MONTGOMERY COUNTY HISTORIC PRESERVATION COMMISSION
STAFF REPORT

Address:	2 East Melrose Street, Chevy Chase	Meeting Date:	5/4/2022
Resource:	Contributing Resource (Chevy Chase Village Historic District)	Report Date:	4/27/2022
		Public Notice:	4/20/2022
Applicant:	James and Emily Petrila (Patricia Mendoza, Agent)	Tax Credit:	N/A
Review:	HAWP	Staff:	Michael Kyne
Permit Number: 989960			
PROPOSAL: Fenestration alterations

Proposed East Elevation
Scale 3/16" = 1'-0"

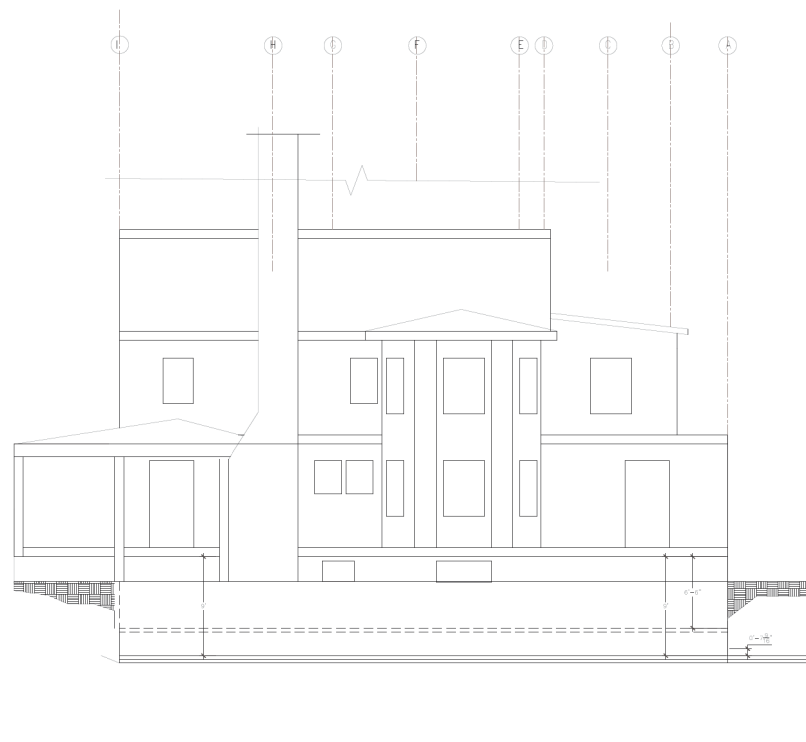
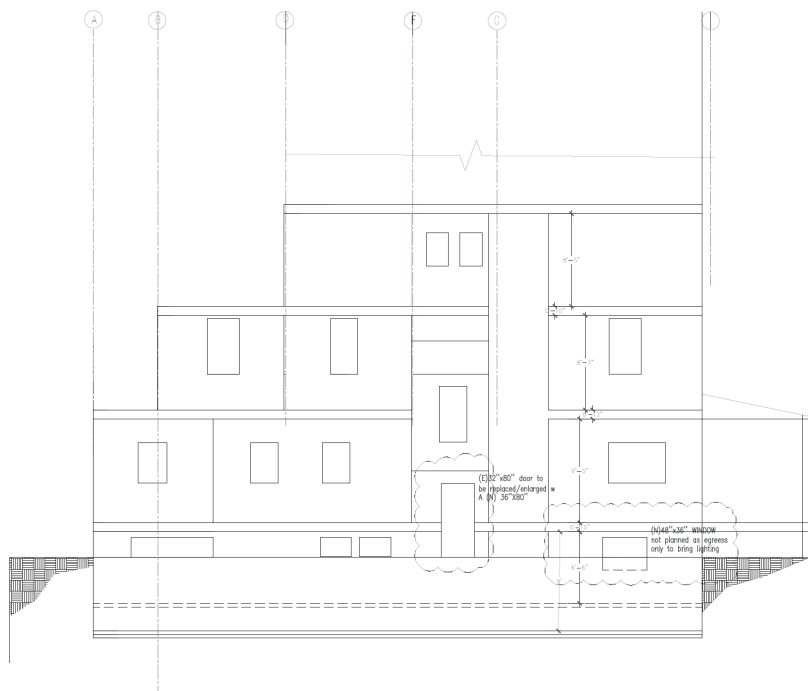
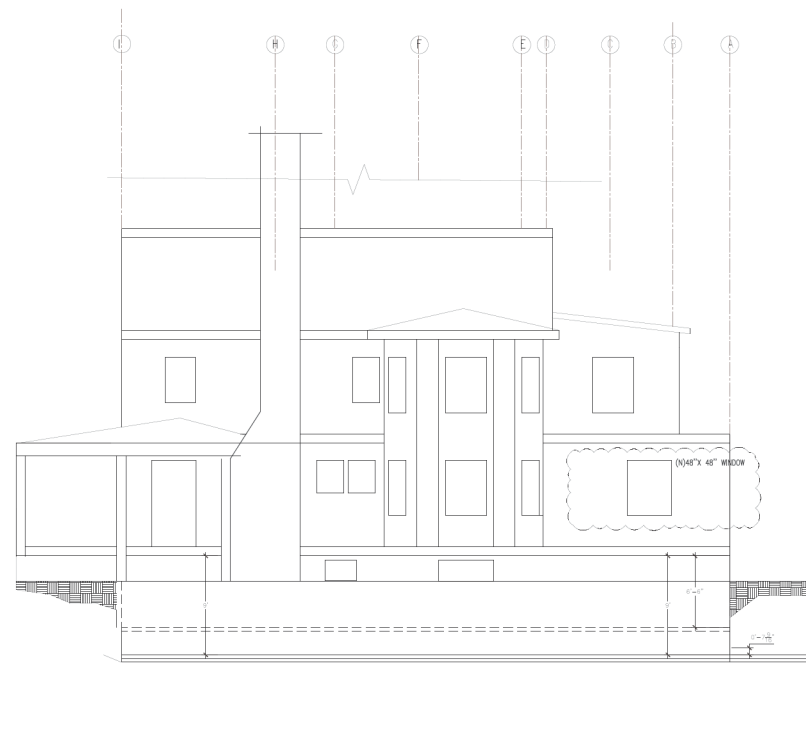
- Conversion of the existing double door at the west (right) side of the existing, non-original bump out at the southwest (rear/right) side of the house to a window. The proposed new window will be a fixed single-lite aluminum-clad wood window. The window will be installed within the existing opening and framing, but the opening will be infilled at the bottom to accommodate the conversion.
- Widening the existing basement-level door at the east (left) side of the historic house, going from 32" to 36" wide. The existing basement door will also be replaced to accommodate the widened opening. The proposed new door will be a four-lite, two-panel wood door.
- Installation of one new basement-level window on the east (left) side of the historic house. The proposed new window will be a 48" wide by 36" high fixed single-lite aluminum-clad wood window.

Staff supports the applicants' proposal. As noted, the proposed alterations are primarily at the basement-level on a secondary elevation, where the Commission typically exercises greater leniency in their review. The bump out at the southwest (rear/right) side of the house is not original, and the proposed door-to-window conversion will not remove or alter original materials or features. Staff finds that the proposed new single-lite fixed windows are generally compatible with the existing windows of the historic house, which are one-over-one double-hung windows with no divided lites.
